Publishing date	06/12/2021
Document number	SUPAIR_2021_12_001
Page number	1/2

SAFETY WARNING : STRIKE2 HARNESS

SUBJECT : Risk of difficulty in extracting the parachute with a STRIKE2 harness

PRODUCT IN QUESTION : STRIKE 2 index A1 harness, all sizes

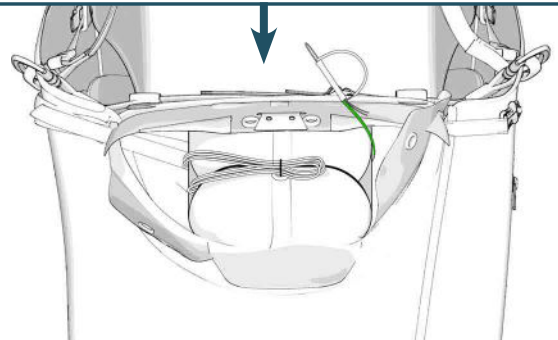
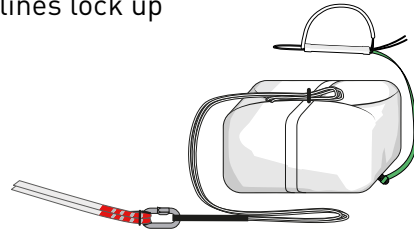
NATURE OF THE PROBLEM : In some cases, depending on the movement made and the volume of the parachute, it may be difficult to extract the parachute from its container.

The type of reserve inner container and the junction locations between the container and the handle are all important for correct operation.

1 Connect the handle to the side loop of the POD.

2 Place the reserve inside the container in the following order :

- bridles and lines
- rescue lines lock up
- handle

Close the container and
**CHECK THE COMPLETED INSTALLATION WITH A
PROPER COMPATIBILITY TEST.**
